RECORD DWGS
AS FABRICATED
6/24/13

TOWN OF WARREN, VT
COUNTY OF WASHINGTON
BRIDGE NO.173 REPLACEMENT
WARREN, VT

ITEM NO.:
PROJECT NO.: BRF 013-4 (14)
REFERENCE NO.:
BRIDGE NO.: 173
STRUCTURAL FILE NO.:

DESIGN: SAF	DRAW: TLB	REVIEW: SAF/RLI	CHECK: CJG
SHOP DETAILS			PROFILES
USB JOB# 51622			SHEET 9t 58

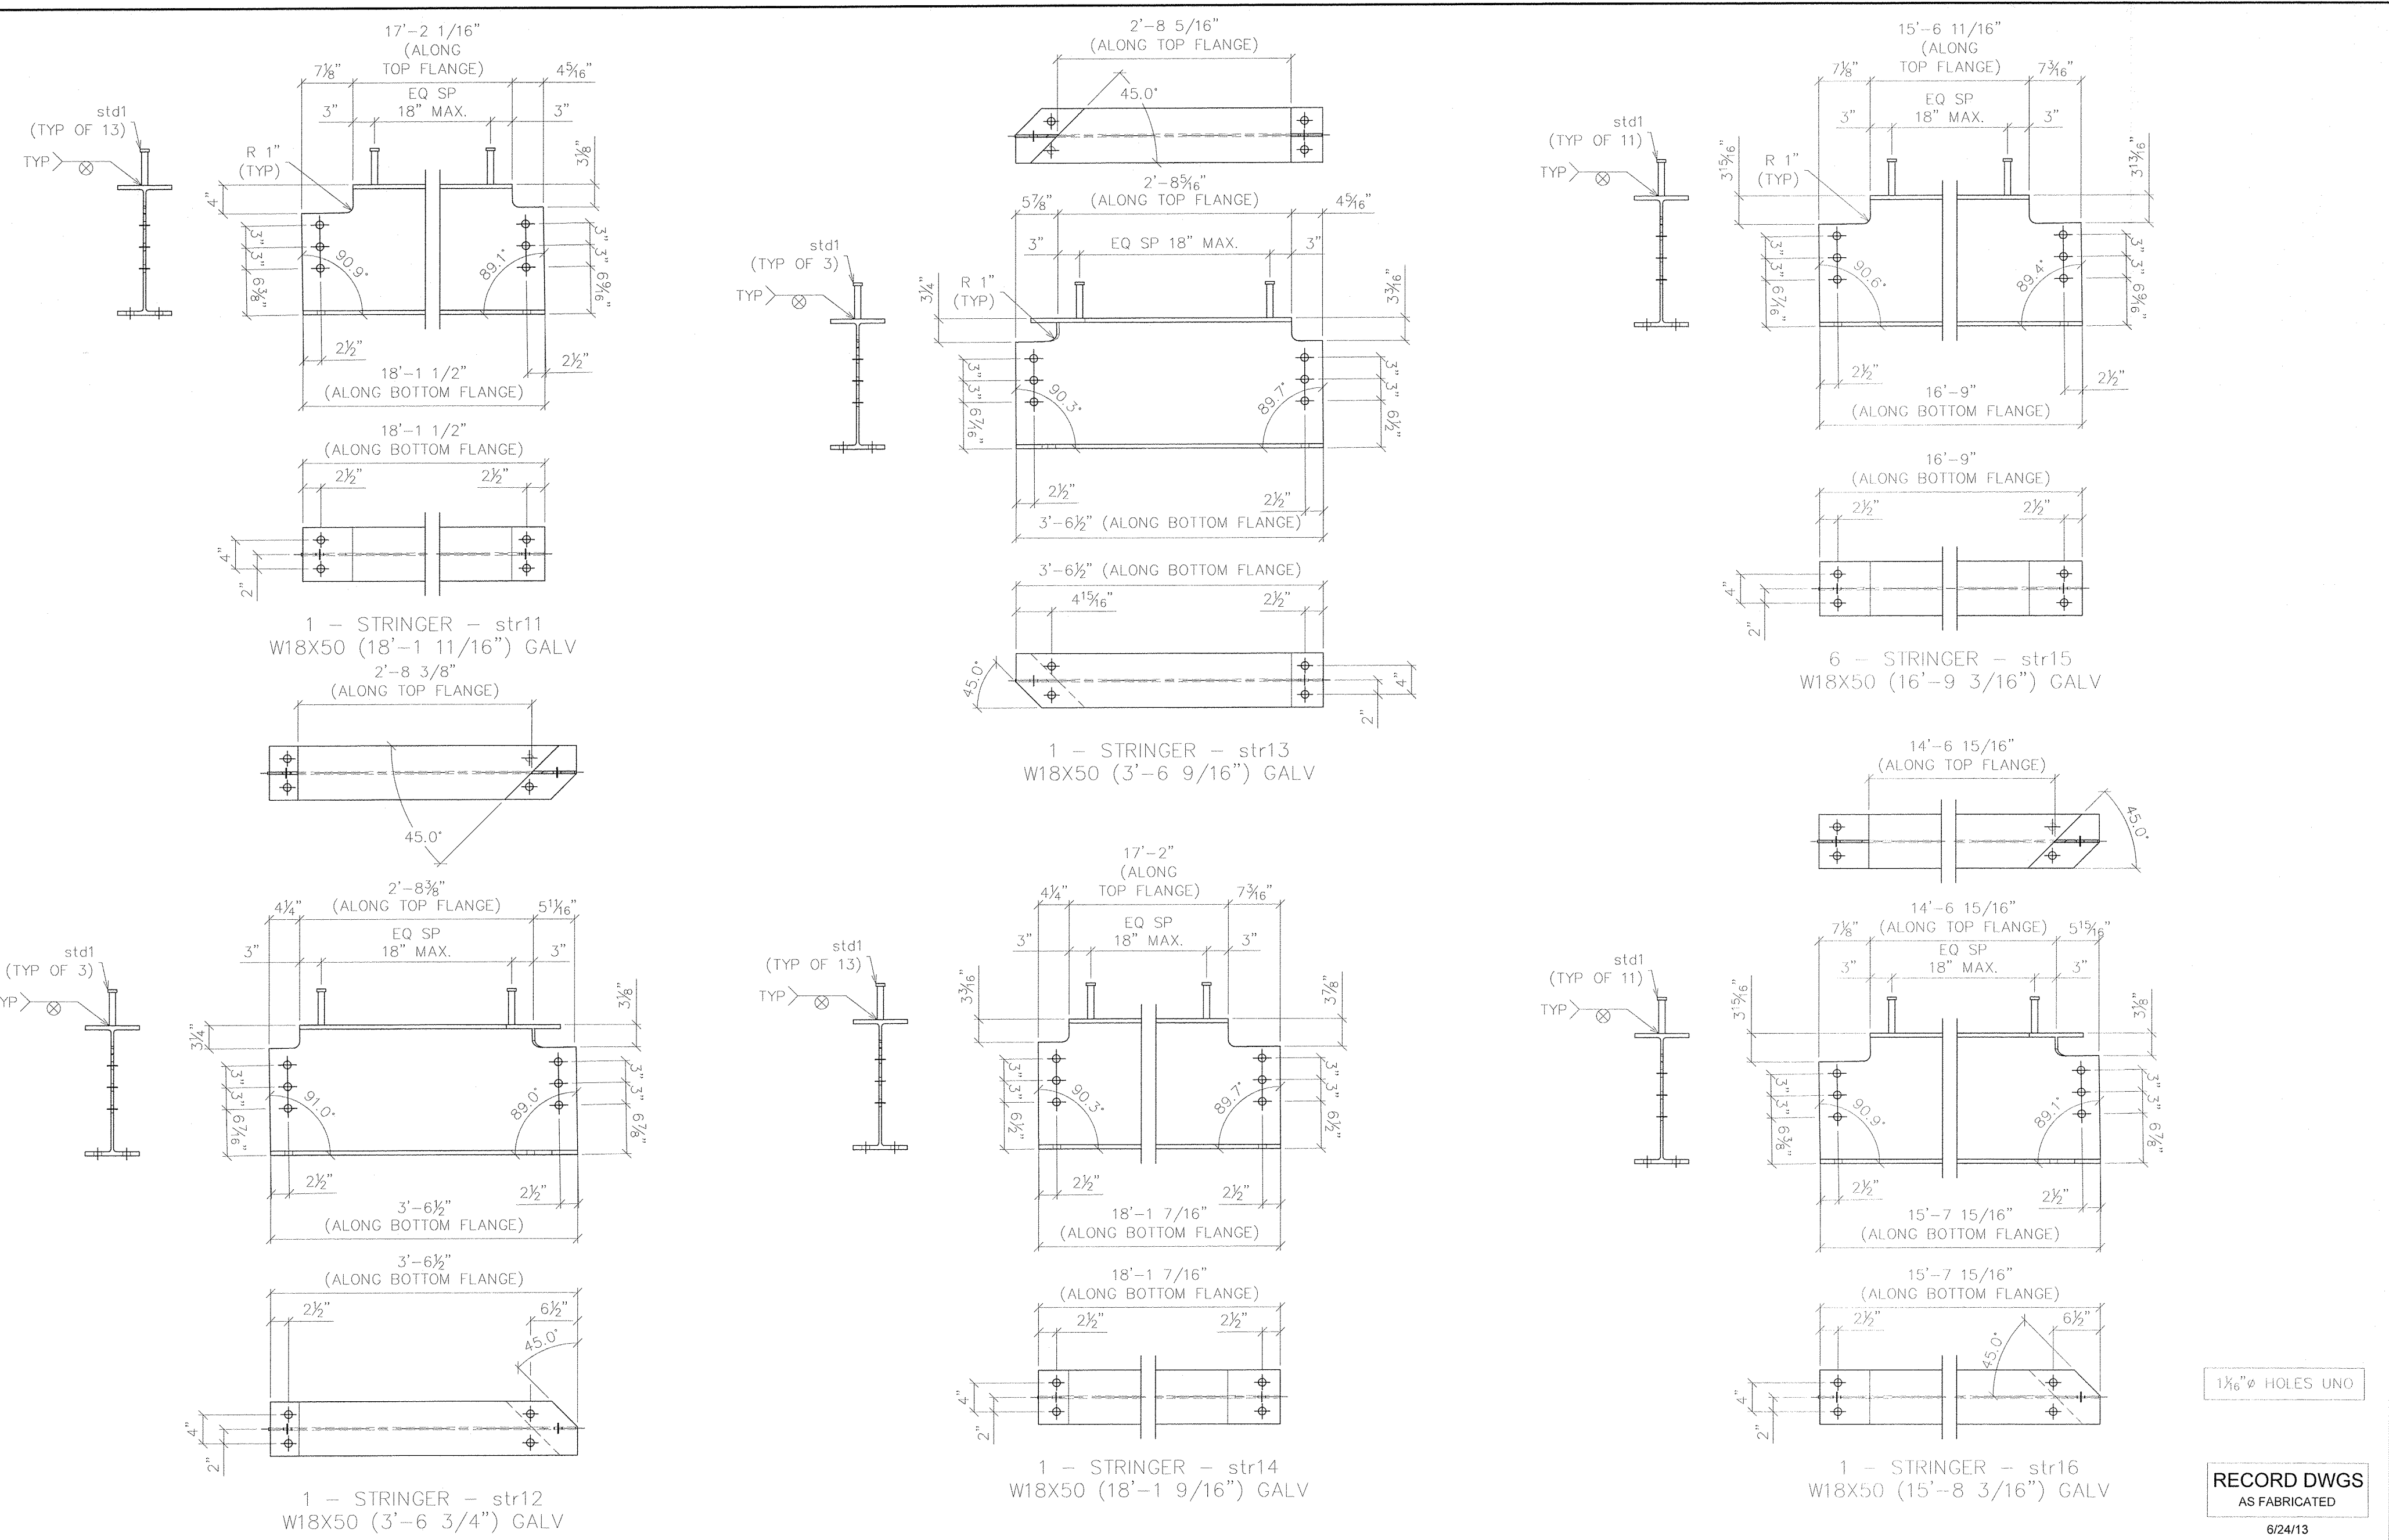
SUBMITTAL LOG	DATE	NO.	DATE	REVISIONS:	BY:
INITIAL SUBMITTAL	12/16/12	▲	5/15/13	FLOOR BEAM END PLATES WAS 1" THK	TLB
RESUBMITTAL NO. 2	2/5/13	▲	5/15/13	ADDED 2" DIA. RAT HOLES IN I61 & I69	TLB
CUSTOMER APPROVAL	2/13/13	▲	5/15/13	CHANGED WELD WAS 3/8" ALL AROUND	TLB
SHOP REVIEW	-	▲	5/15/13	CHANGED BOLT PATTERN	TLB
PRE FAB MTG	-	▲	5/15/13	WAS 2" EDGE DISTANCE	TLB
APPROVED FOR FAB	2/28/13	▲	6/3/13	DIMENSIONAL ERRORS	TLB
